**Regular Council - Land Use**  
**B.7 7922-0221-00, 7922-0222-00**  
**Monday, November 20, 2023**  
**Page Replacement**

FILE: 7922-0221-00 & 7922-0222-00

RE: **Agenda Items B.7, November 20, 2023 Regular Council – Land Use**  
**Rezoning Application Nos. 7922-0221-00 & 7922-0222-00**  
**7790 King George Boulevard & 7850 King George Boulevard**

#### Affordable Housing Program/Relocation Strategy

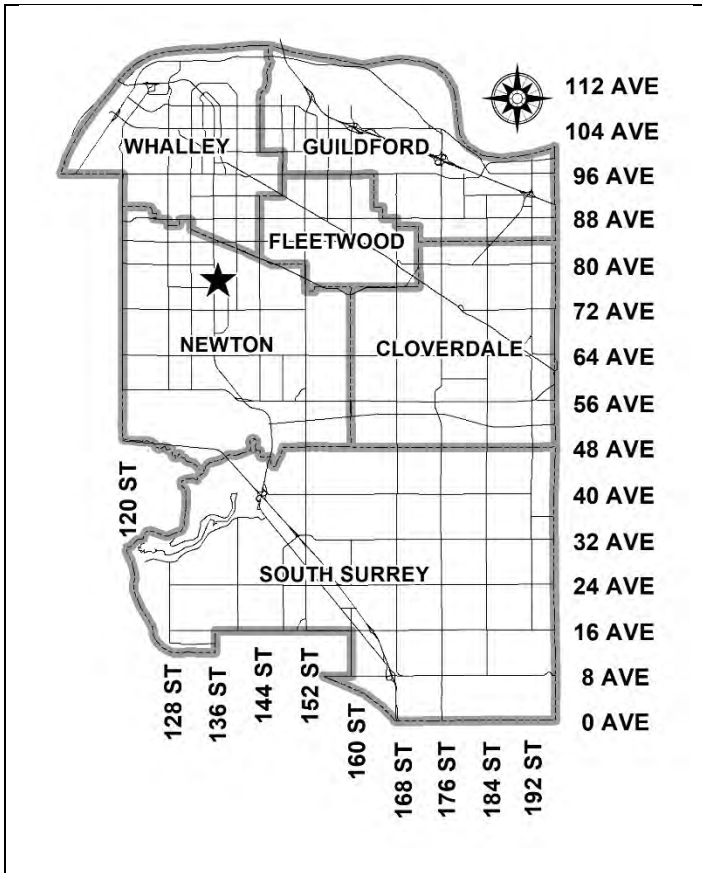
The Planning Report for Development Application Nos. 7922-0221-00 & 7922-0222-00 is being brought forward consideration by Council at the November 20, 2023 Regular Council - Land Use meeting. Upon finalization of the Report, an error was identified on Page 15 which indicates the following:

Page 15 of the Planning Report has been updated to note that the value of a doublewide manufactured home is \$300,000 relative to the \$350,000 noted in the report. This section of the report should note the following:

- Option A: Sell the manufactured home for the greatest value of the following:
  - Singlewide unit: \$250,000
  - Doublewide unit: ~~\$350,000~~ **\$300,000**
  - 2022 BC Assessment Value of the manufactured home; or
  - What the tenant paid for their home + 10%”

- Option A: Sell the manufactured home for the greatest value of the following:
    - Singlewide unit: \$250,000
    - Doublewide unit: ~~\$350,000~~ \$300,000
